Stratford Renewable Energy Hub Submissions Report

The proposed Stratford Renewable Energy Hub would comprise a Pumped Hydro Energy Storage (PHES) with an indicative generation capacity of 3.6 gigawatt-hours (i.e. 300 megawatts [MW] over 12 hours), alongside a complementary photovoltaic solar farm facility (Solar Farm), collectively referred to as 'the Project'. The Solar Farm would have an indicative capacity of approximately 320 MW alternating current (equivalent to 375 MW direct current), to supply a portion of required energy to 'charge' the PHES.

In response to submissions received on the EIS, Yancoal has prepared this Submissions Report to provide an analysis of the submissions received, summarise the actions taken since lodgement (including additional engagement activities, further assessments and proposed refinements), and provide responses to issues raised and an updated evaluation of the Project.

FIGURE 4-13.1a

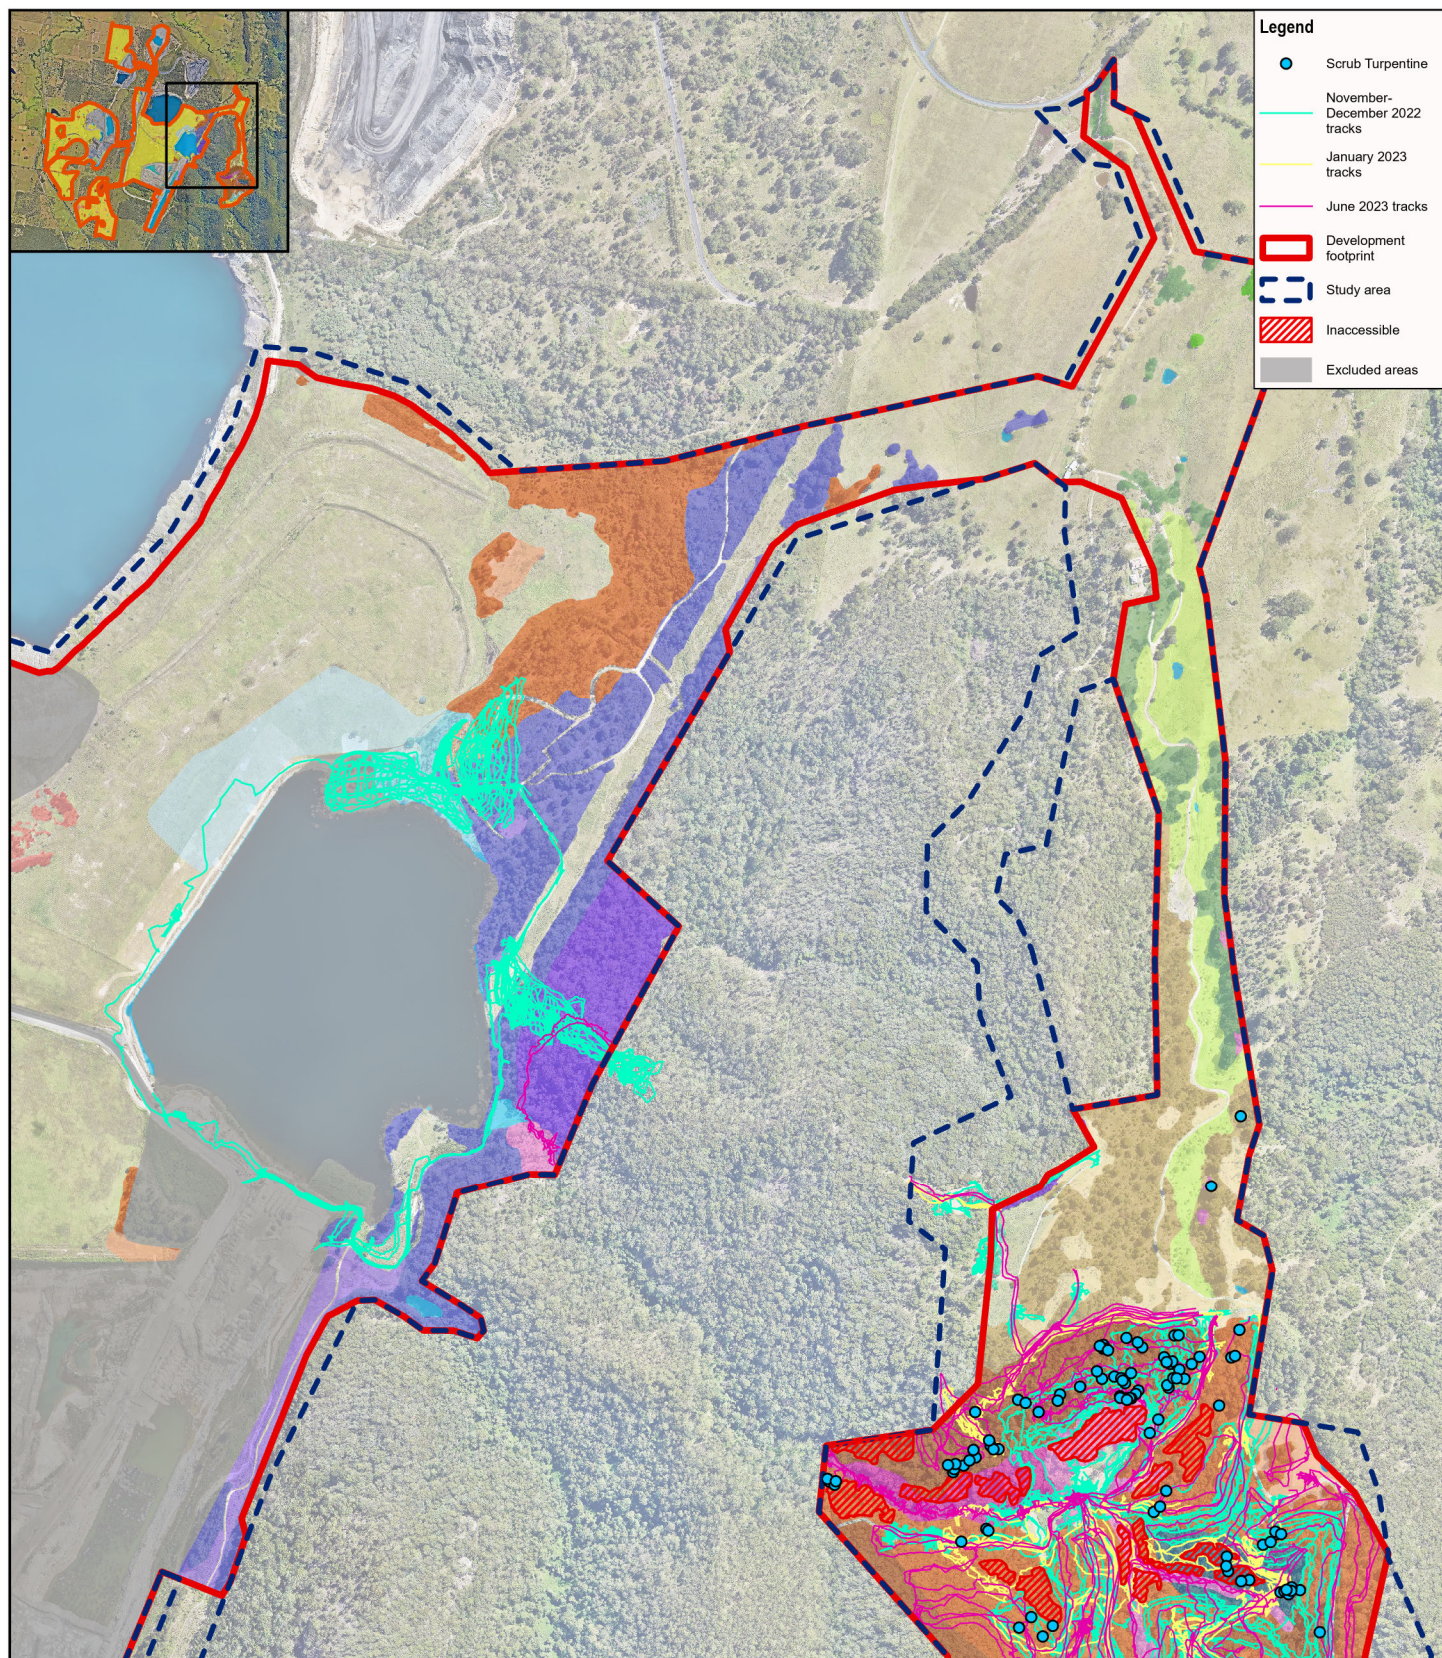
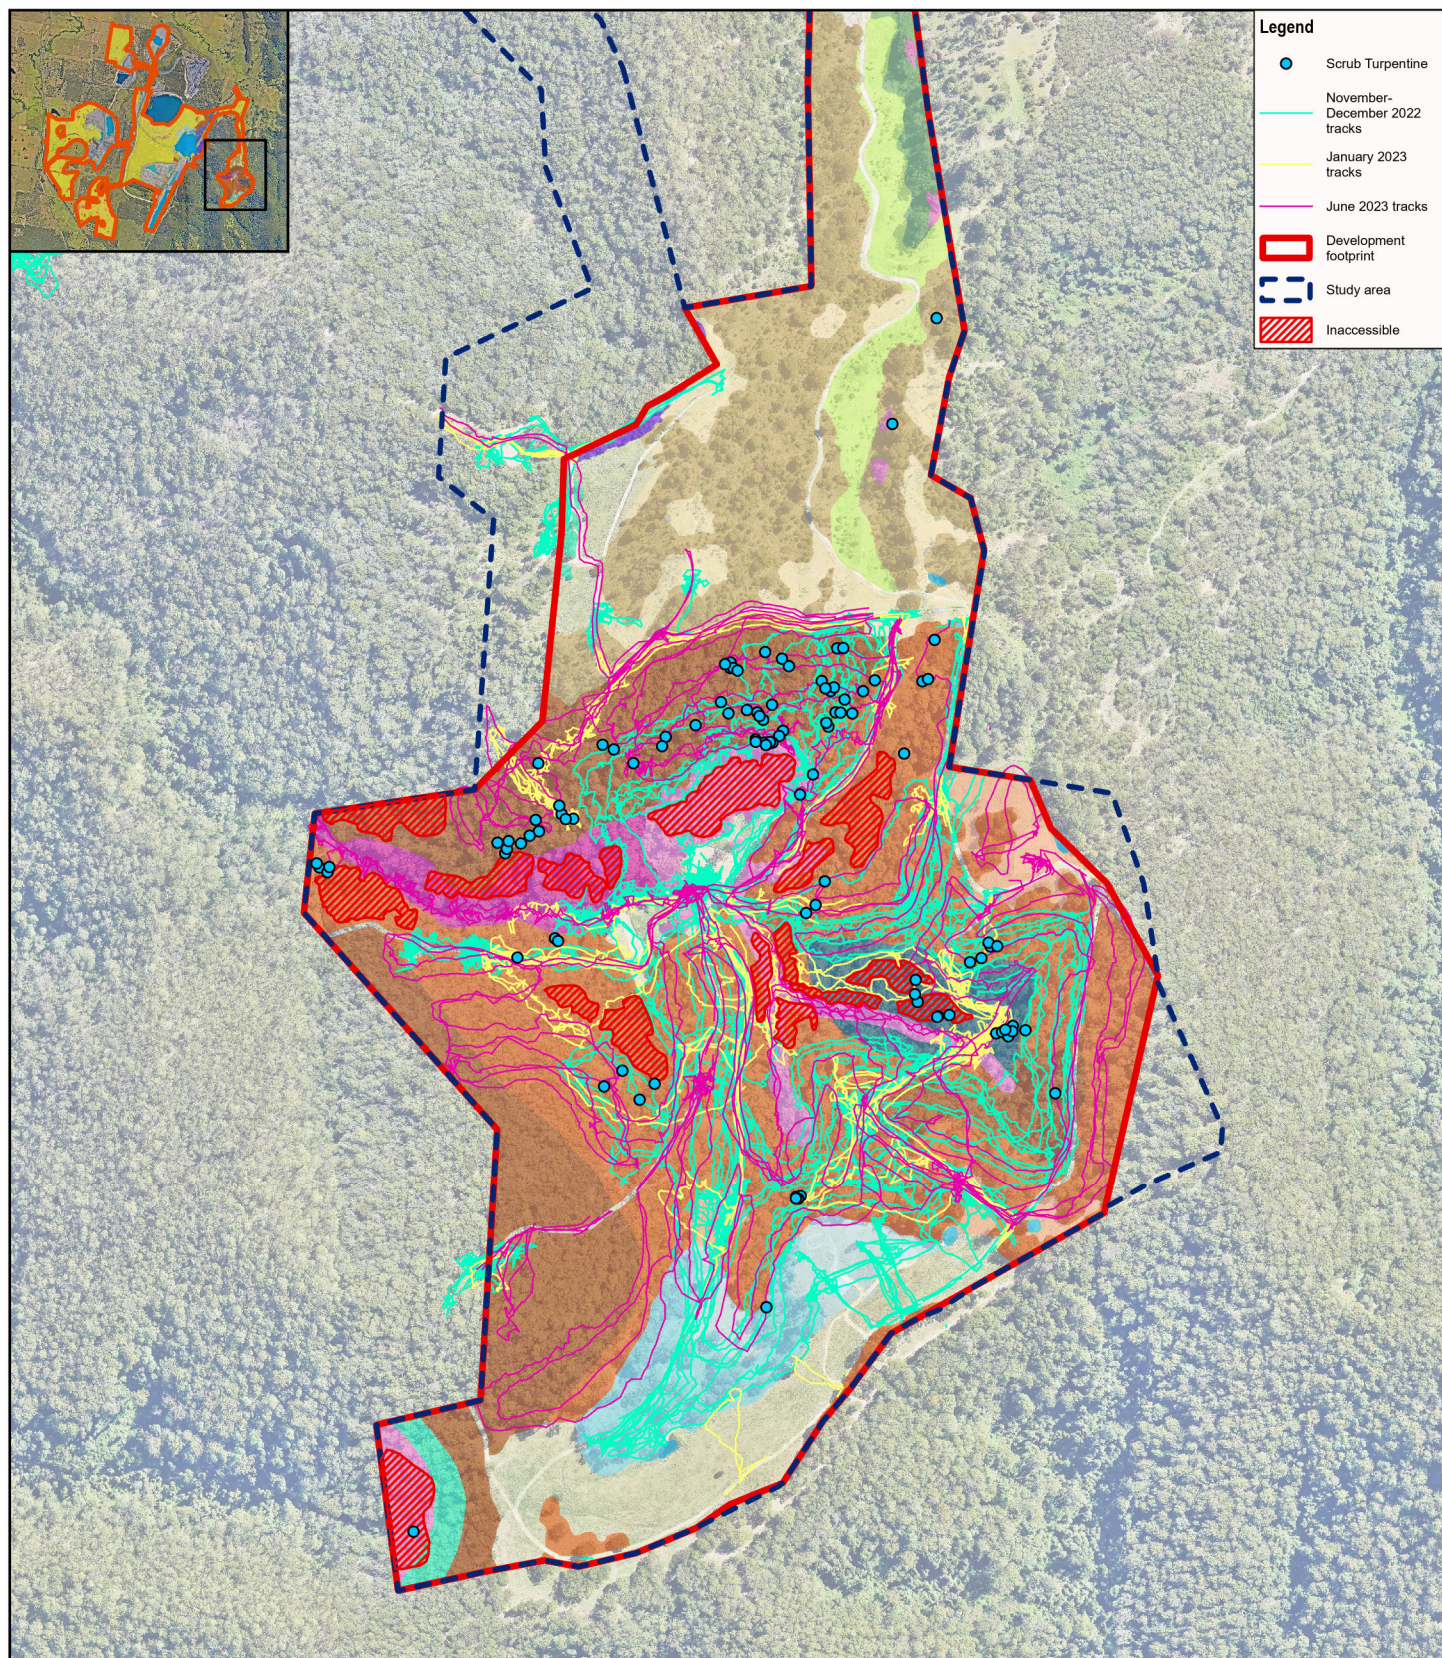
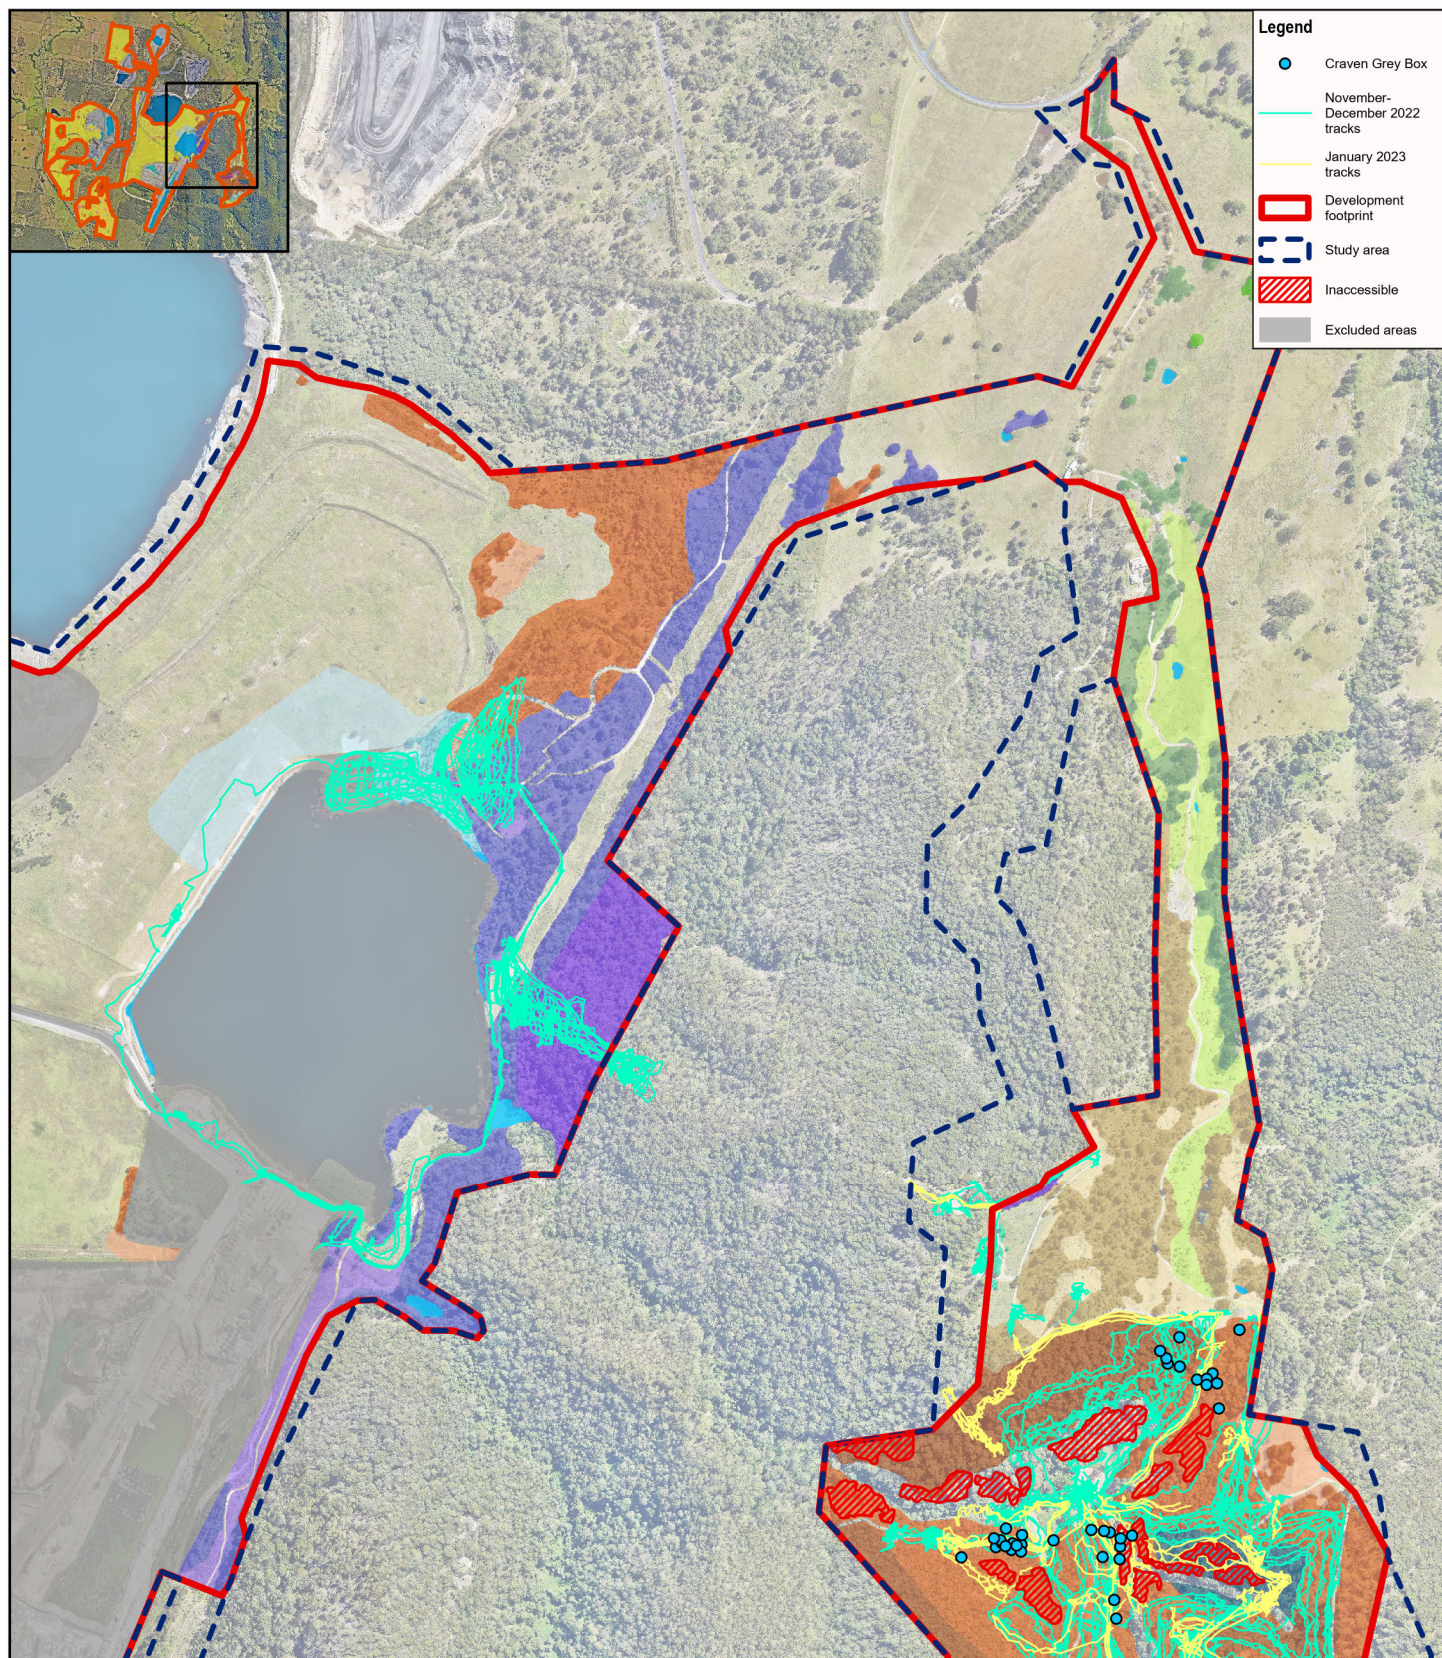
BCS does not consider the targeted flora searches conducted between November 2022 and January 2023 (BDAR Figure 3.3) to be adequate. The assessor has stratified targeted searches, and searches do not cover PCTs 3170, 3086, 3241 or 3244 comprehensively. These searches were conducted across two growth forms (being tree and shrub species) within closed vegetation and therefore should have been completed 10 m apart, as per Section 4.1 of the Guideline. These PCTs are suitable habitat for the SAIL entity, Rhodamnia rubescens, and therefore should be comprehensively searched.

Species	Stem Count or Area Count	Conclusion in the BDAR Regarding Species Presence	Further Assessment Proposed (Yes/No)	Justification
Scrub Turpentine (<i>Rhodamnia rubescens</i>)	Stem count	Present (651 species credits)	No	See Figure 4-13.1 for survey effort. While surveys were completed at a distance greater than recommended, the survey effort completed to date is considered suitable given the following: - Multiple survey rounds were completed for other candidate flora species which allowed for the opportunistic observation of the species. This is supported by the fact that Scrub Turpentine was identified many times opportunistically over the course of multiple surveys completed outside of the dedicated survey round. - The target species is distinct and easily identifiable, and thus easily identified during surveys for other species/habitat. Additionally, the species can be surveyed any time of the year, as per the TBDC (DCCEEW, 2025a). Whilst not officially being targeted at other times of the year, the species is readily identifiable and subsequently was recorded opportunistically.
